# Town of Hilton Head Island Regular Design Review Board Meeting

Tuesday, June 24, 2014

## AGENDA

**Sunset Pavilion:**

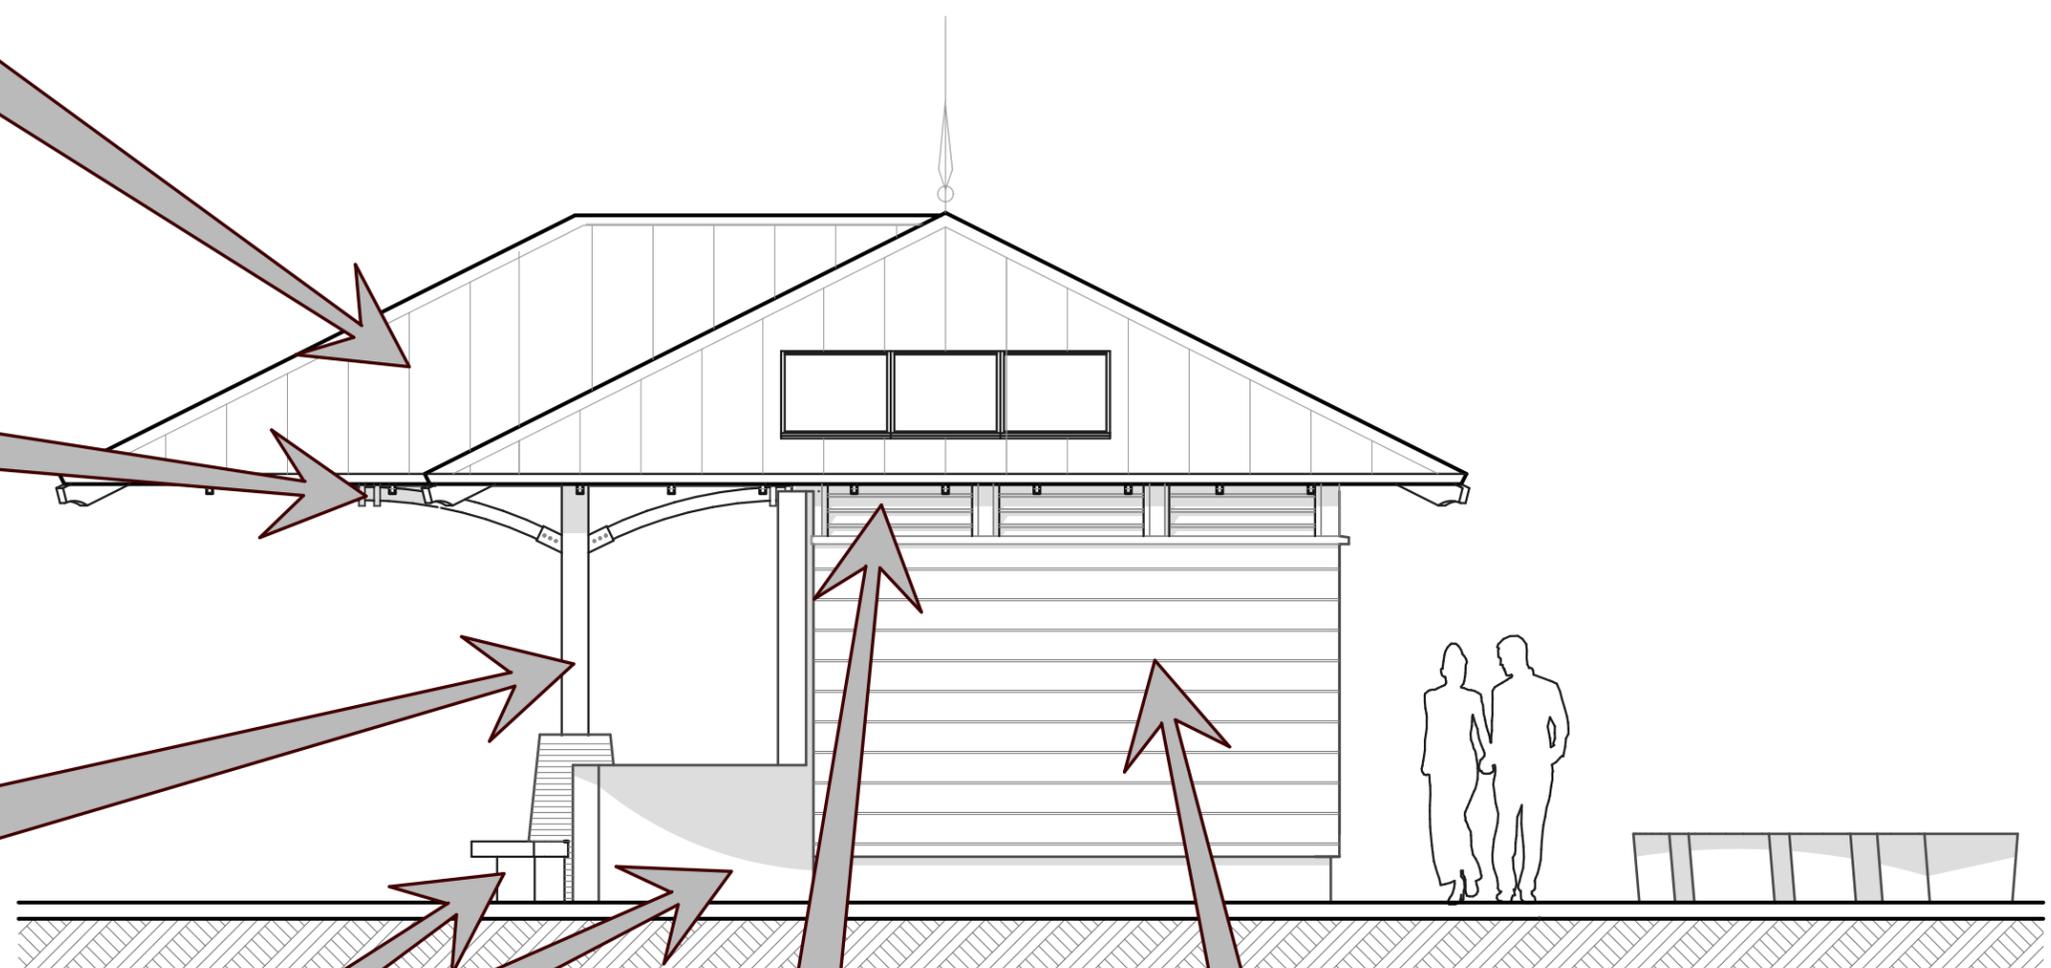
- (2) More columns were added and the bench was moved away from the wall to allow for seating for everyday use. This will allow for a more direct path to the bathrooms from the playground.
- The roof was changed from an inverted sloped roof to a traditional hip roof with exposed rafters.
- The siding was changed from IPE to nickel joint cypress siding. We have also added louvers to allow for more air flow into the bathrooms.

**ENTRY AREA CONCEPTUAL SITE PLAN WITH PROPOSED PLANTINGS**  
SCALE: 1" = 20'-0"

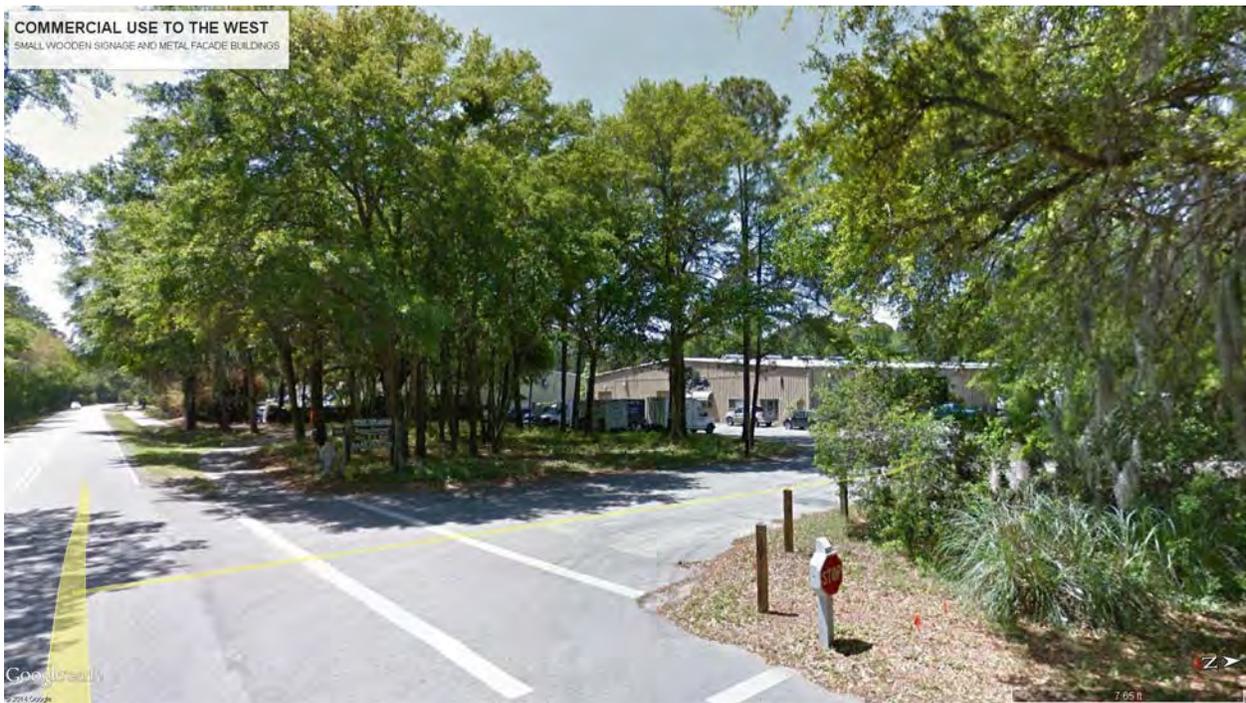
Entry walls (stucco with pre-cast cap) are in keeping with neighboring styles as well as developer’s other properties on the Island. Each sign can be no larger than 40 SF so this will need to be revised before the final submittal. A sign permit application will be required for the signs once the development name, logo, and font is determined.

TENNIS BLDG. PLAN.

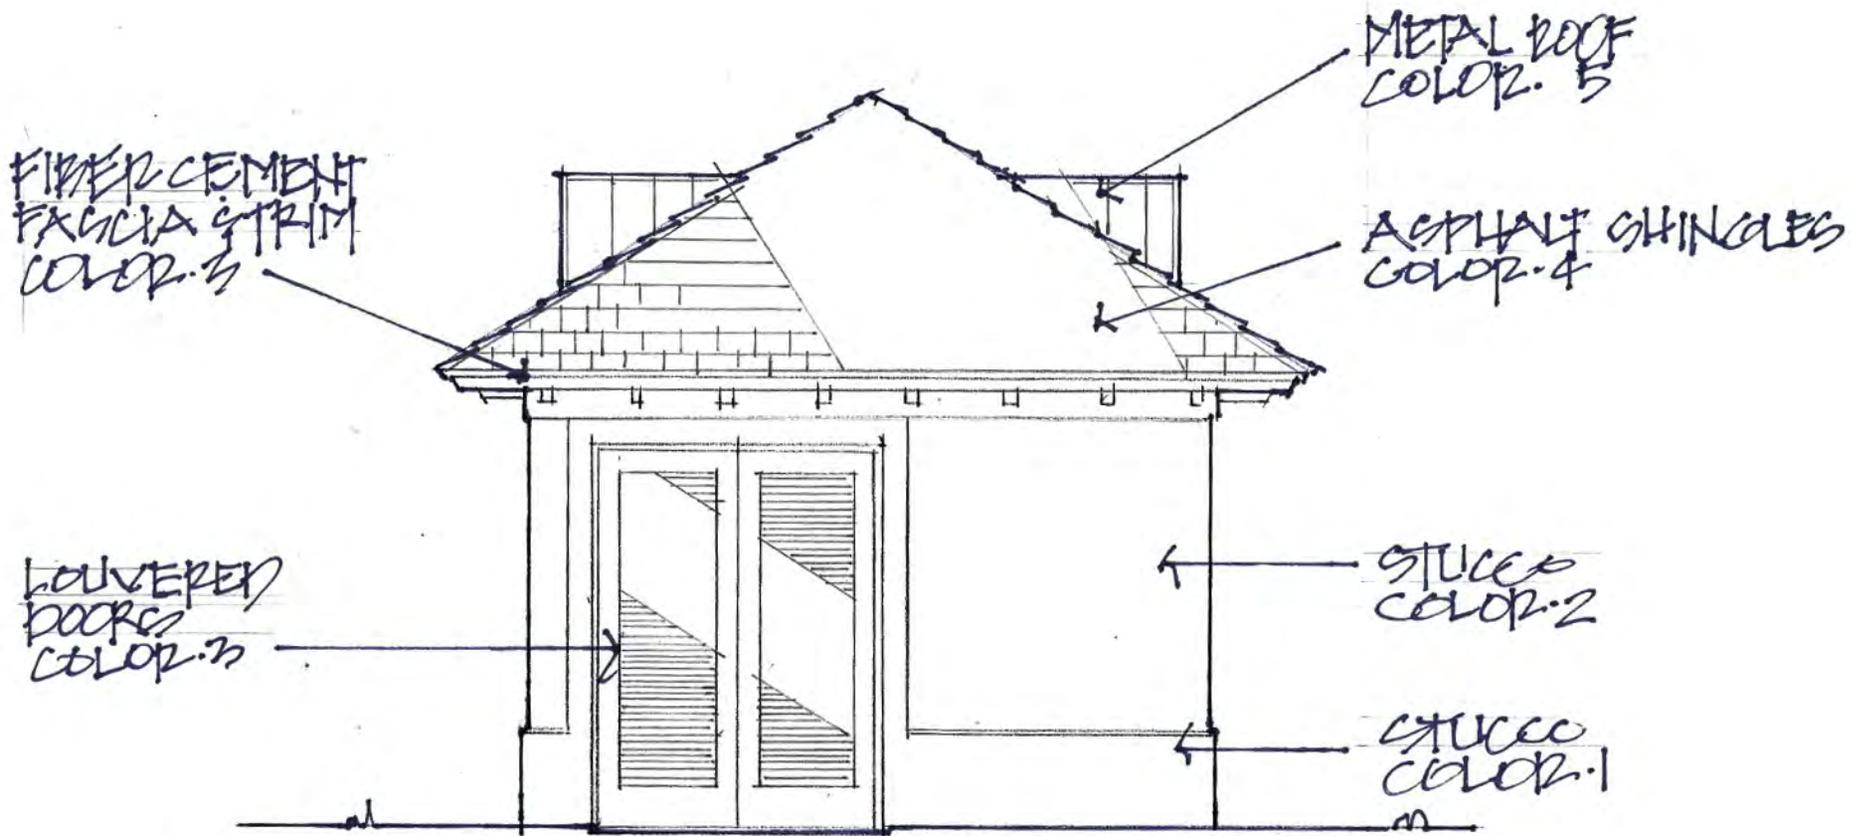
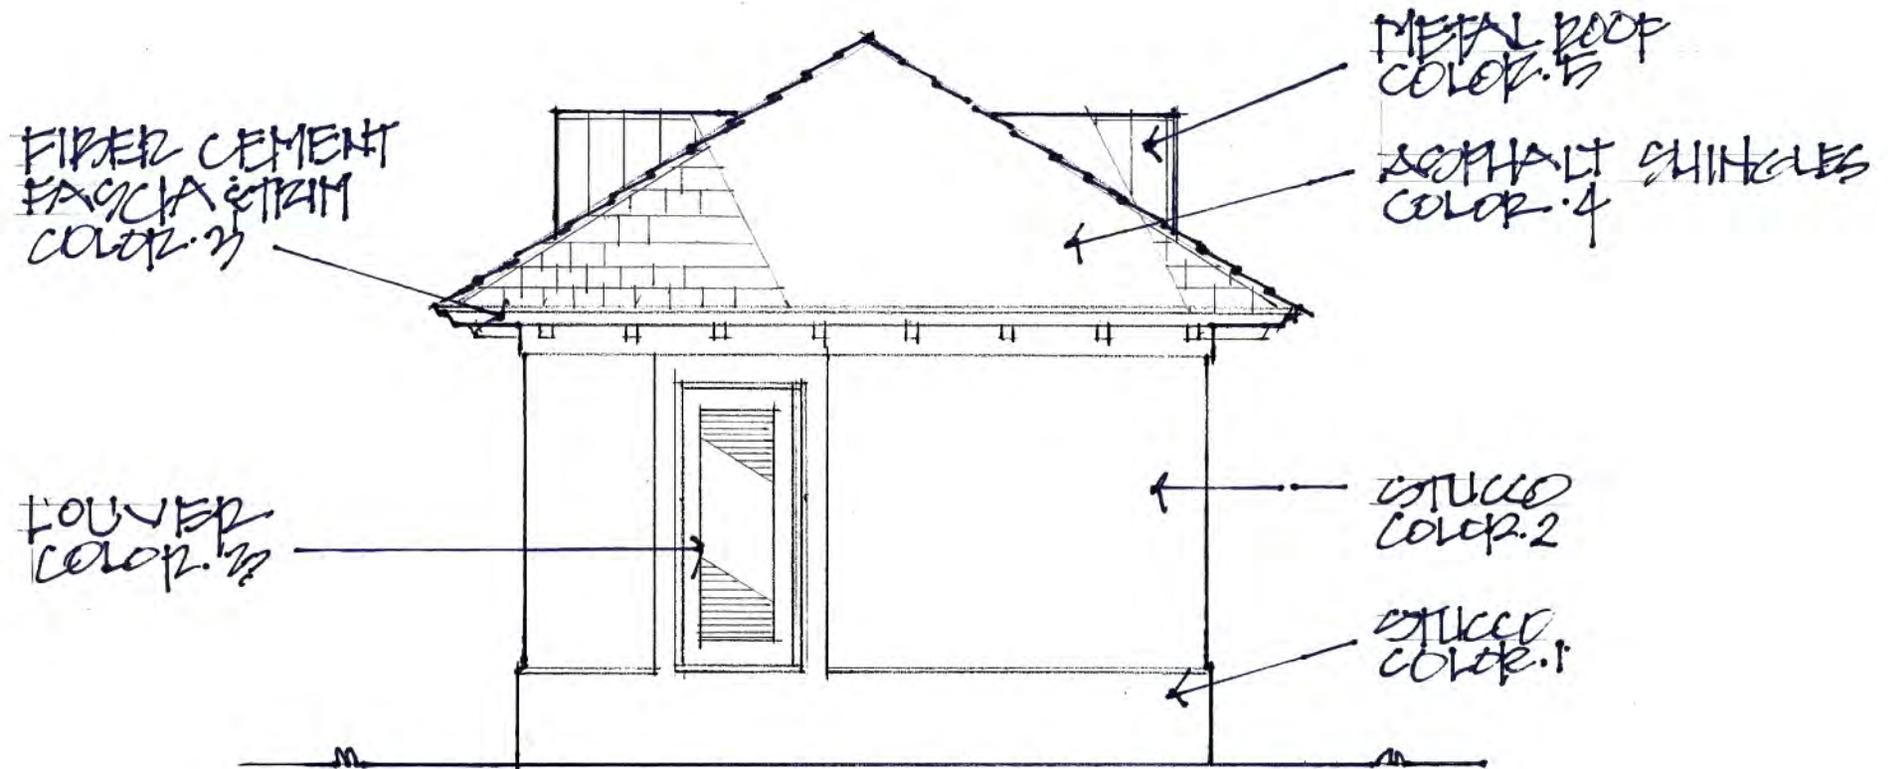
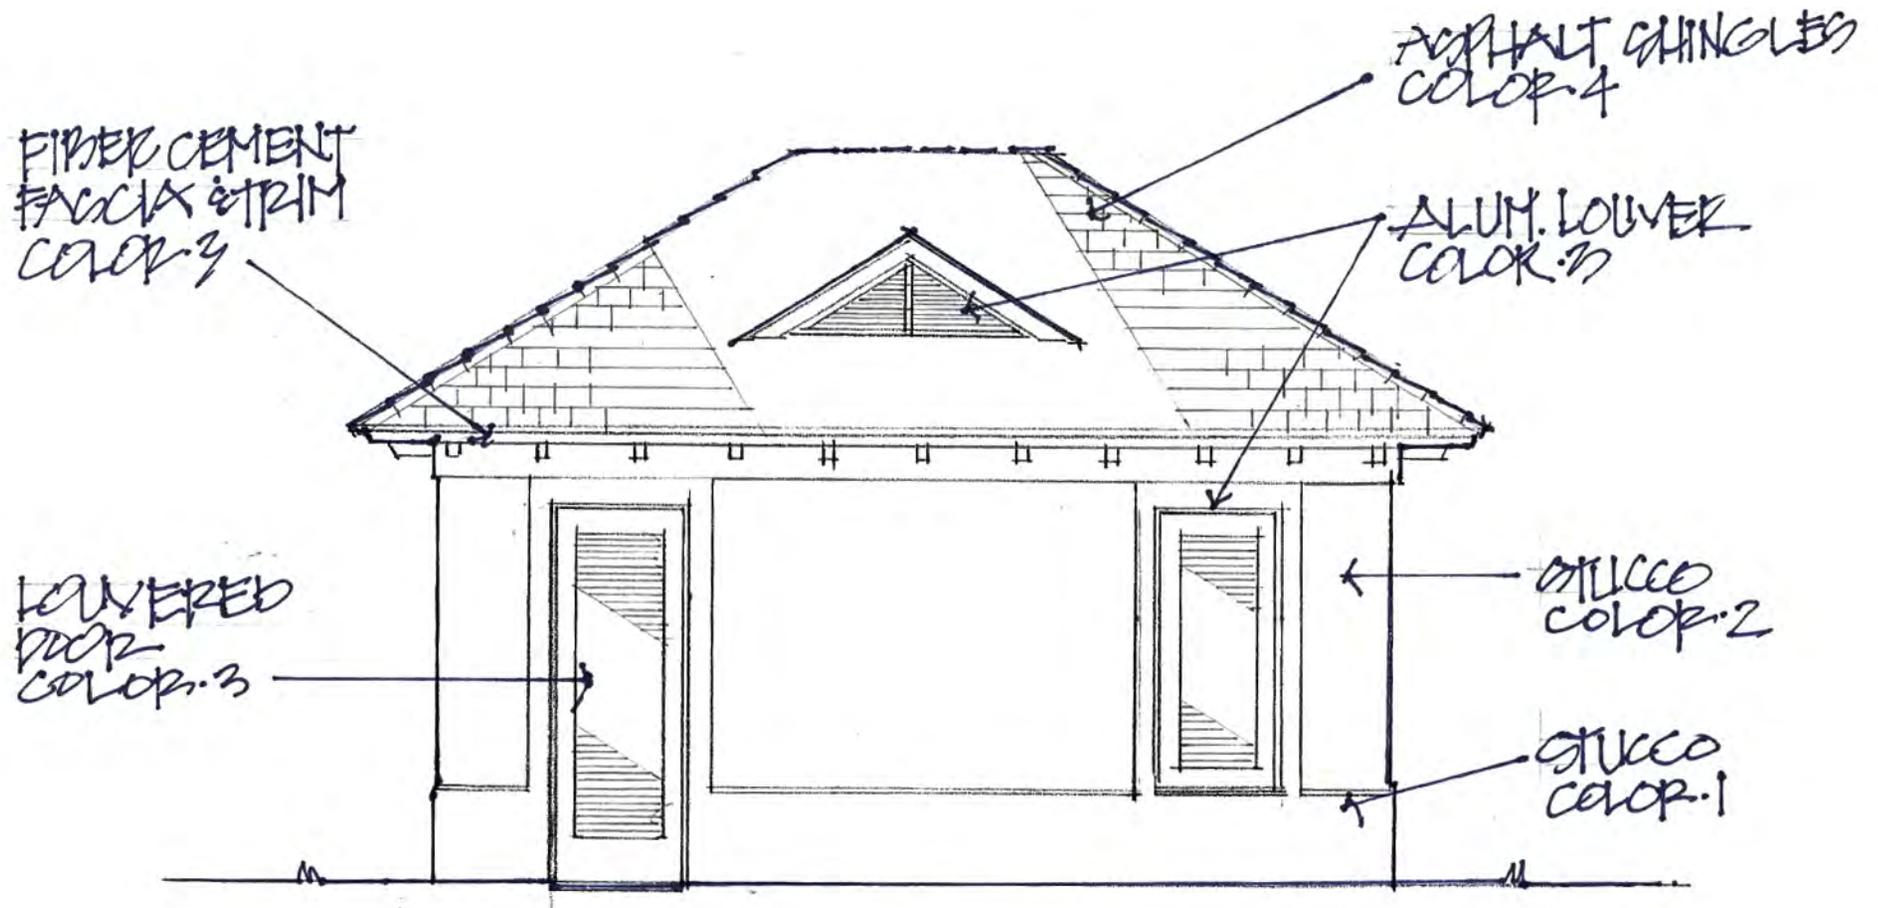
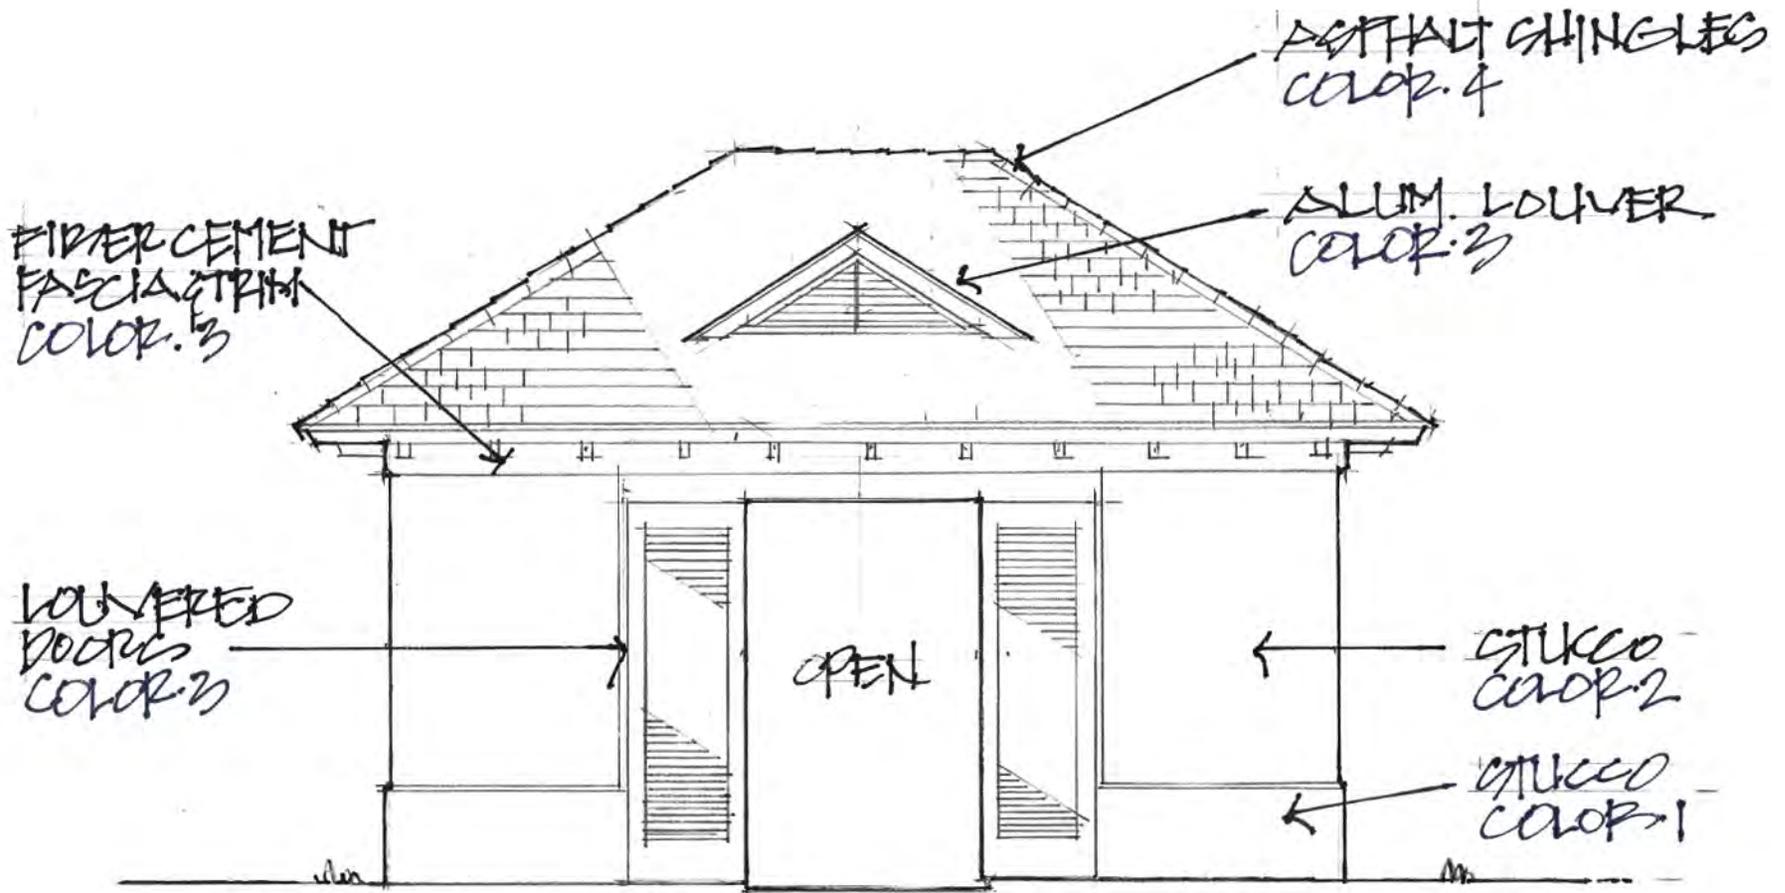
If the tennis building is the only facility for the tennis courts, both male and female restrooms are required and both must be accessible. If there are separate toilet facilities within 500 feet and on the same property, these facilities can act as those required for this area per IBC sections 2902.2 and 2902.3.2. If the plan is changed to accommodate two restrooms, the buildings shall still remain under the 300 square foot maximum requirement per title 15 of the Town.
